**RE: CLOSED CITY OF HELENA LANDFILL
POST-CLOSURE PLAN ADDENDUM - APPROVAL**

RE: CONSTRUCTION APPROVAL—HELENA CENTENNIAL PARK
Closed City of Helena Class II Landfill (Lic. # 90)

**RE: APPROVAL—LANDFILL FINAL USE / HELENA CENTENNIAL PARK
Closed City of Helena Class II Landfill (Lic. # 90)**

RE: Closed City of Helena Landfill – License #90
Proposed Centennial Park Preliminary Enhancements
Investigation to Determine the Location of Historic Garbage
Approval to Proceed

FLOWABLE FILL PLUG DETAIL

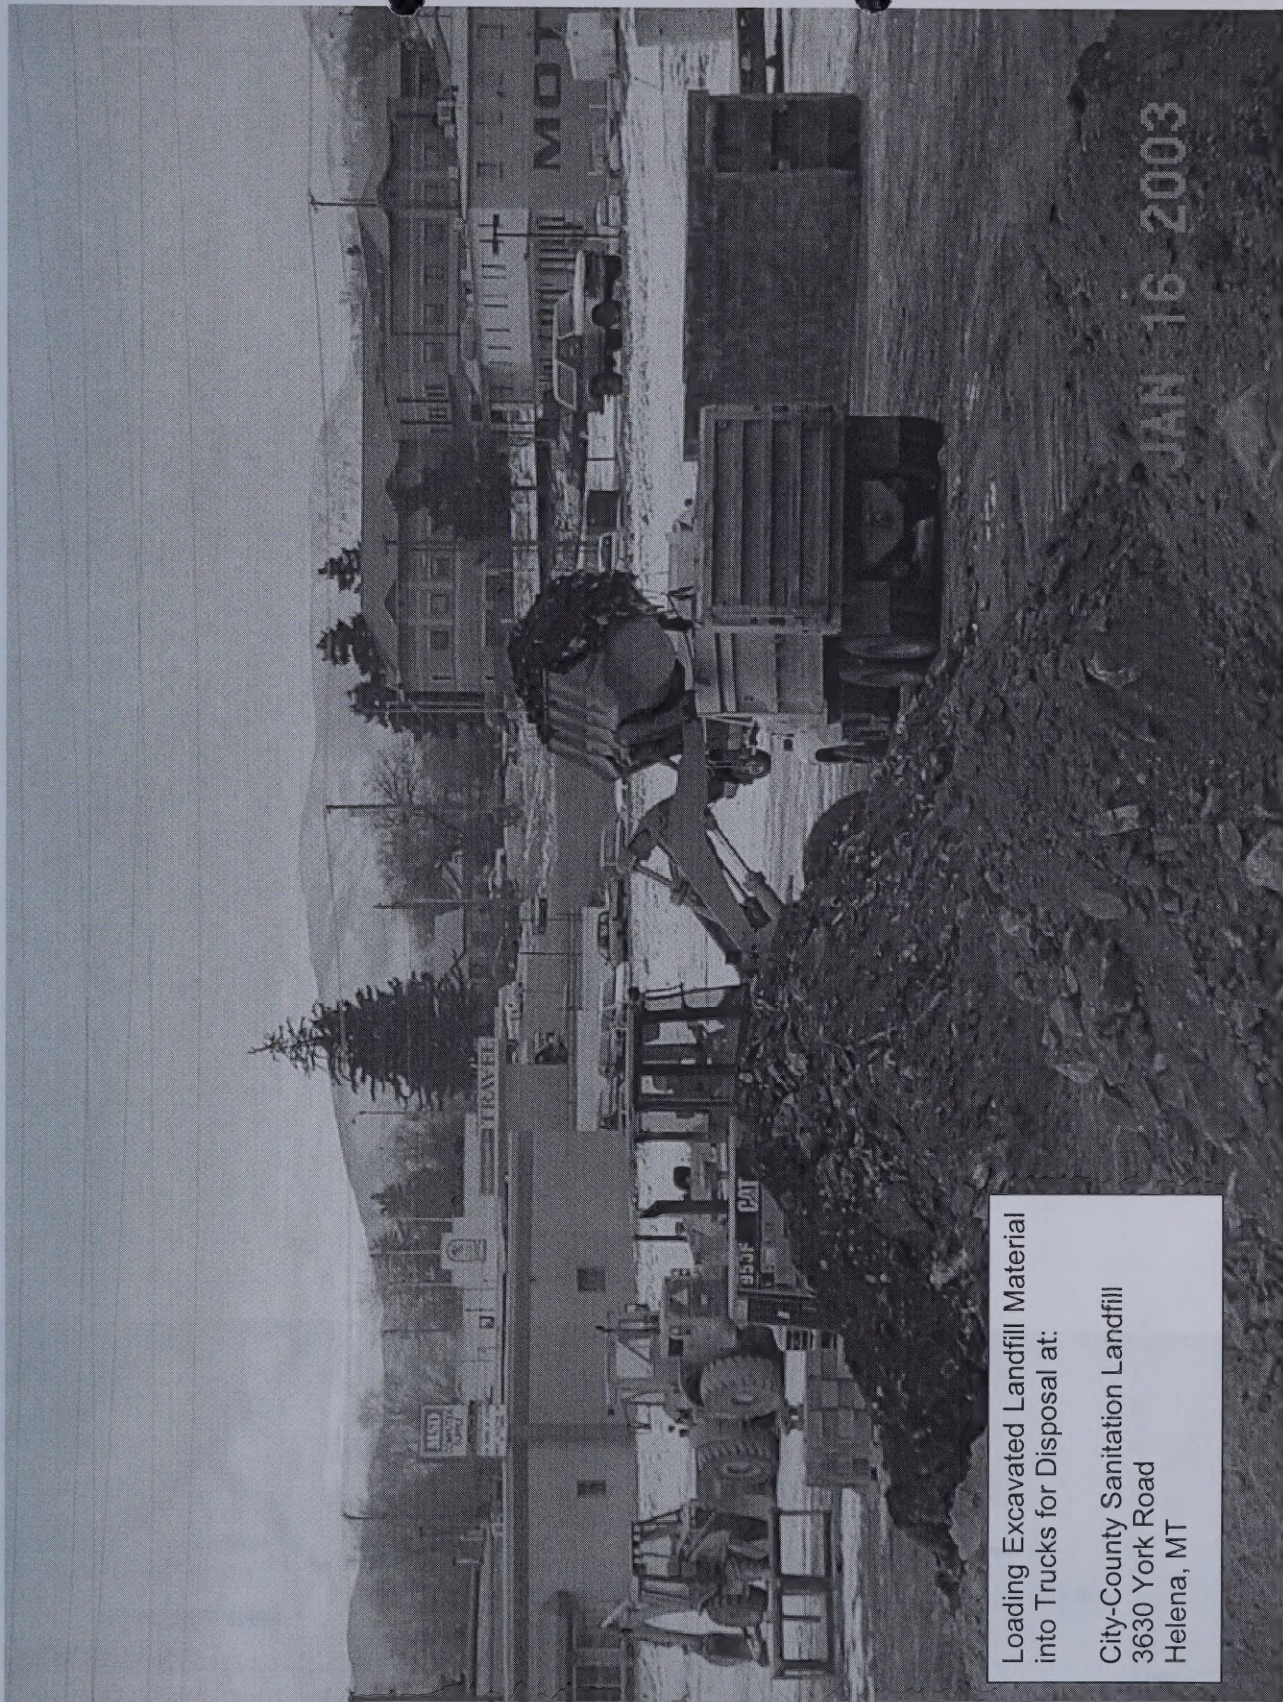
Purpose: To prevent migration of methane gas from landfill

Use no bedding in this area. Backfill trench with Flowable Fill to create plug

Envelope pipe with Flowable Fill. 2 ft above and below pipe and 2 ft into undisturbed soils on each side of trench.
